Agenda Supplement

December 13, 2023
HDC Meeting

Applicant Submitted Information

1801 Washington Ave.

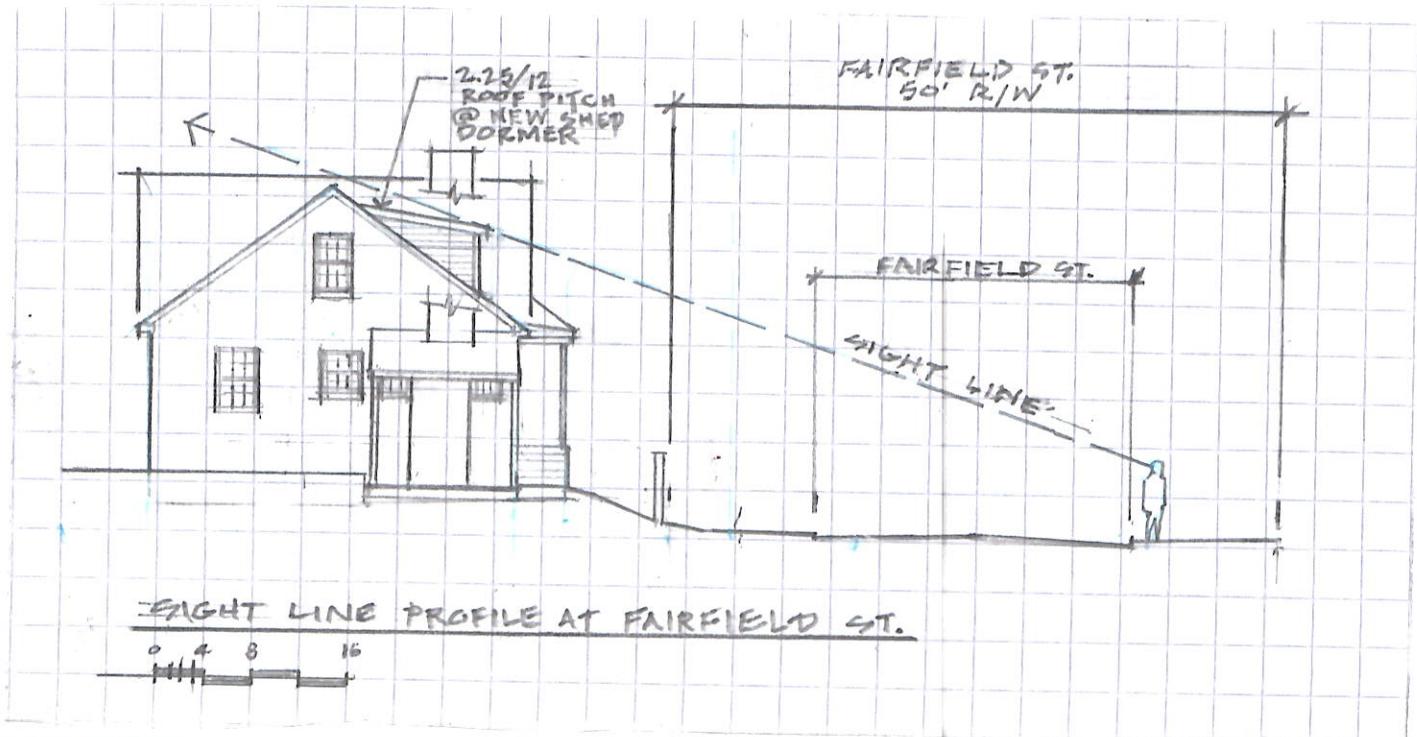
1. Screen porch addition over existing patio a. What are the dimensions of the fiber cement siding? Fiber cement panels are 6 -1/4" wide with 5" exposure. b. The screen porch is completely reversible. Yes, Screened Porch can be removed with minimal disruption to the existing structure.

2. Dormer addition on left elevation a. What are the dimensions of the fiber cement siding? Fiber cement panels are 6 -1/4" wide with 5" exposure. b. What is the corner board material and dimensions? Corner Boards are fiber cement $\frac{3}{4}$ " thick x 2-1/2" wide. c. Window specifications that meet HDC Standards are needed for the awning windows. d. What is the pitch of the shed roof dormer? The pitch of the Shed Dormer Roof is 2.25/12. Is it possible to use asphalt shingle siding instead? Due to the low pitch, wind blown rain may be forced up the slope and compromise the roof's integrity. Roofs lower than a 3/12 pitch are not recommended to have shingles as the roofing material. This is why a standing seam metal roof is proposed. Sight line from the adjacent side street does not allow the Shed Dormer's Roof to be visible, due to the angle of view. (See Sight Line Profile Below)

3. Right elevation changes a. Provide a brick and mortar sample for the areas to be infilled.
4. Window repair/replacement a. Confirm that all windows will be retained and repaired, and none are proposed for replacement other than the right elevation changes as noted above? All existing windows will be retained and frames, sashes, and muntins repaired. Existing Simulated Divided Lite 'Picture Window' at Living Room to be removed and replaced with a single French Door to provide access to the Screened Porch. b. Staff can work out the details of the storm windows.

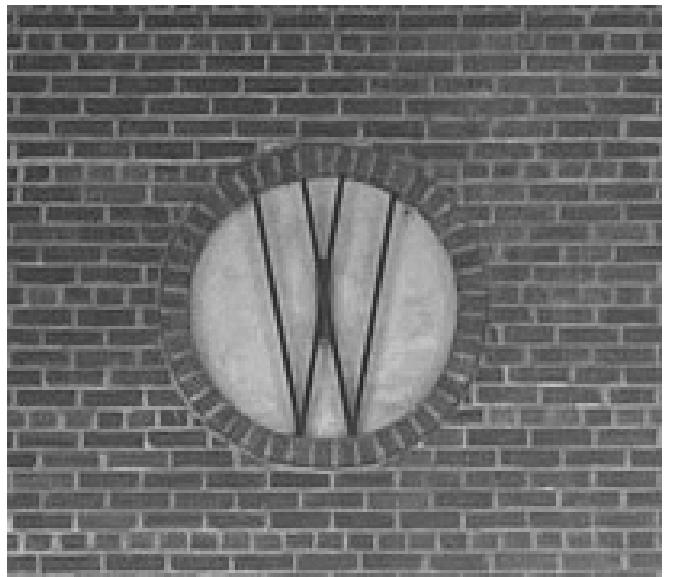
While we acknowledge the applicants' continued effort to revise the design of the rooftop addition, we still do not believe the rooftop addition complies with the following HDC Design Standards:

Section 4.5: Rehabilitation of Building Elements – Roofs - Items 3 & 6

Section 7.17: Commercial Additions - Items 1, 2, 5 & 6

We believe the basement and rear addition elements of this project are fully compatible with the HDC Design Standards. If additional square footage beyond those additions is necessary to make this project viable, we believe that square footage should be added to the rear of the building not to the roof. The glass and metal structure currently being proposed to be built on top of the historic Leeper Wyatt building is approximately 850 square feet. That additional square footage could instead be added to the rear of the building by extending the rear addition across the full width of the building and housing any building equipment on the roof as is very common for commercial buildings with flat roofs.

Email From Salem Hertigage After Site Visit

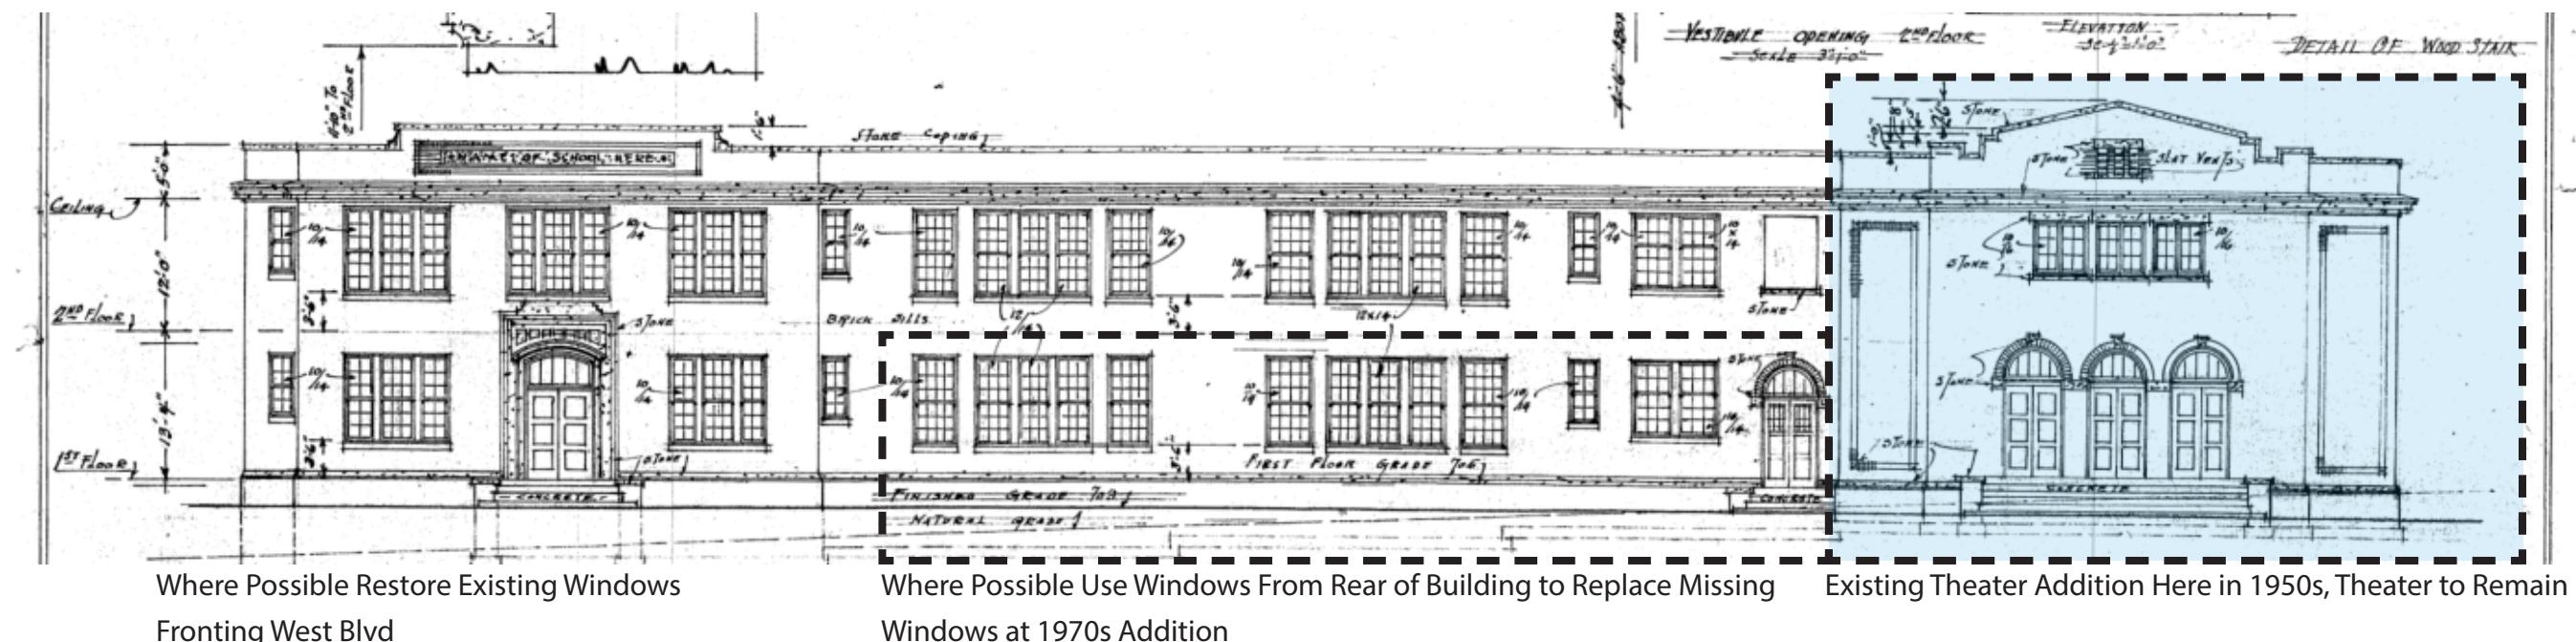
As we discussed, the vast majority are in fairly good shape, just needing cosmetic renovation. However, the missing windows where the addition was added on the south elevation, and some of the severely damaged existing windows are going to need to be replaced with new windows of similar design.

Proposed Development – “Gateway” Apartment Building

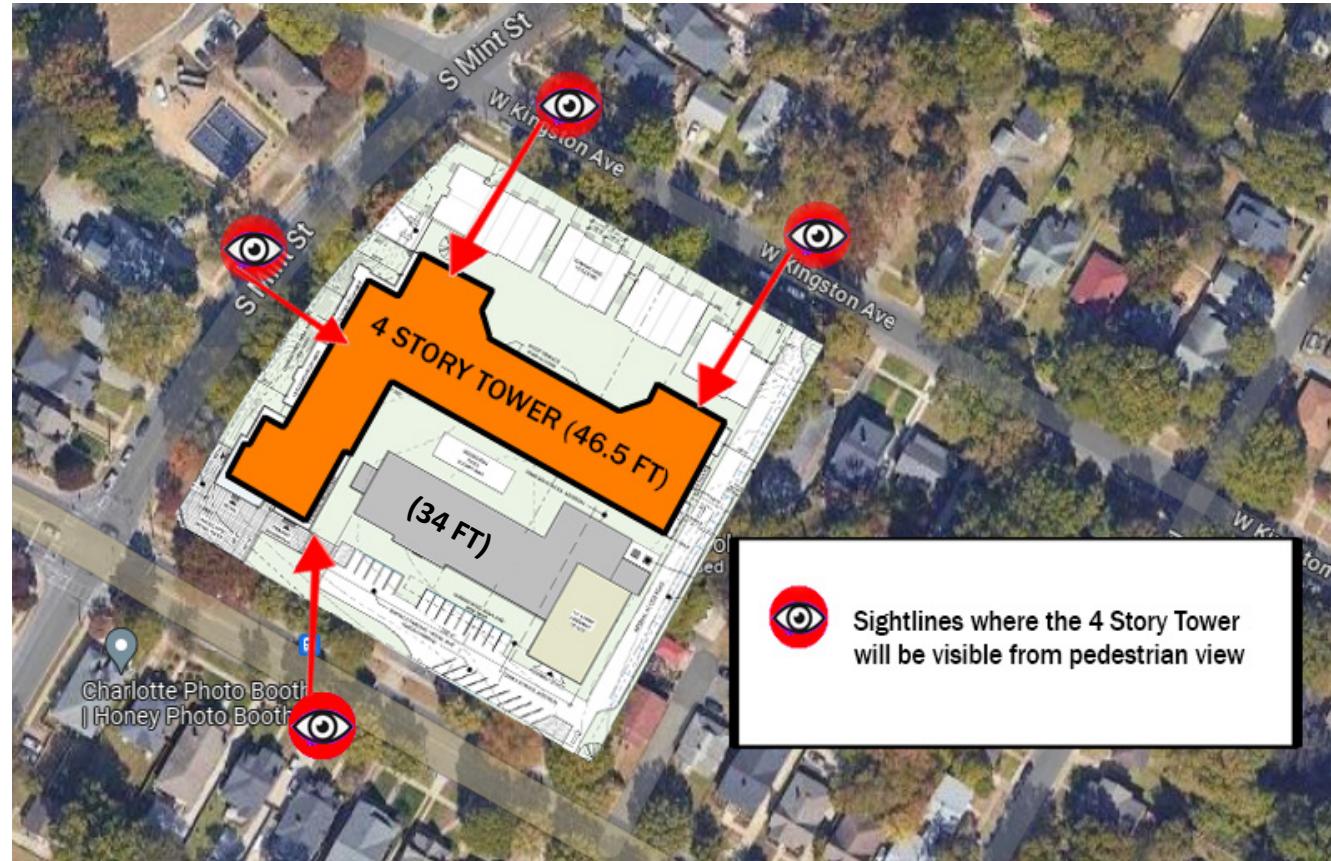
Proposed tower will be significantly visible from different pedestrian viewpoints.

This will undermine the Historic Wilmore School and the context of the neighborhood.

Railing Picture Re: Comment 3.a.

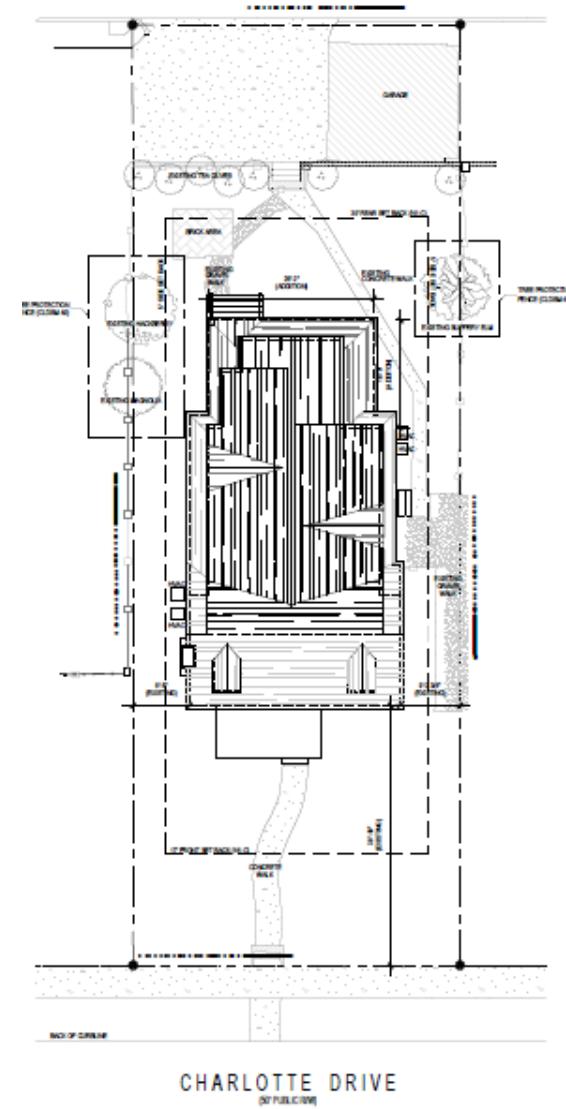
3.a. Front porch railings appear to be vinyl

This was mislabeled - see attached pictures of
existing, wooden, railings on front porch. Plans to be
updated.

View from Street Re: Comment 4

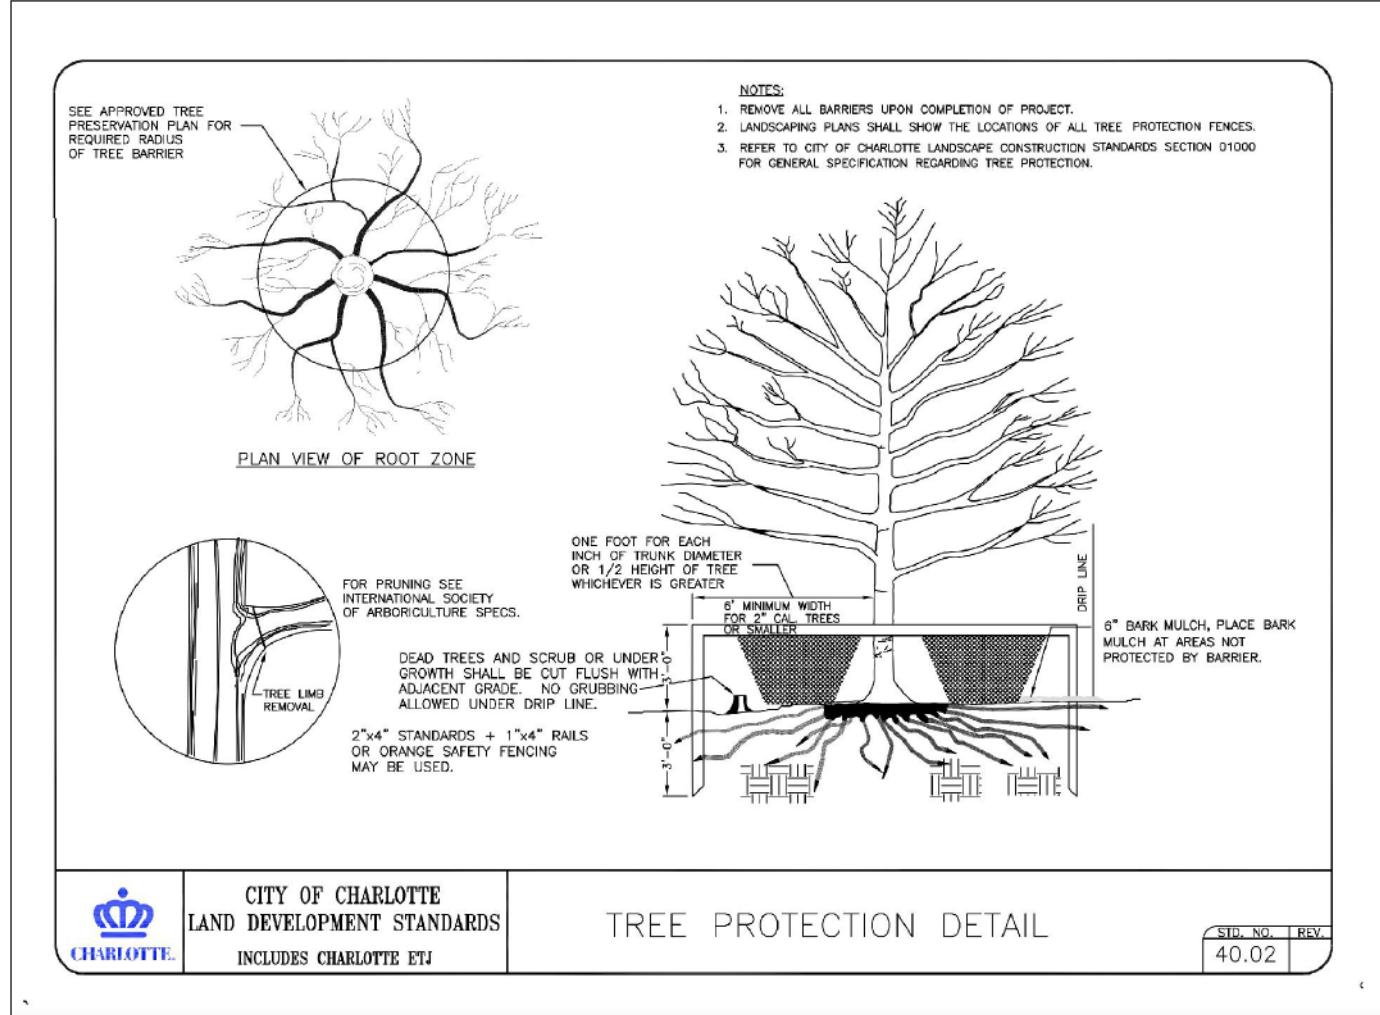
The Commission has approved non-traditional
materials for horizontal surfaces of decks
4 however not when visible from the street

Owner would like to keep material, Trex, as shown
due to quality. View from street is not fully clear due
to mature landscaping - see pictures below.
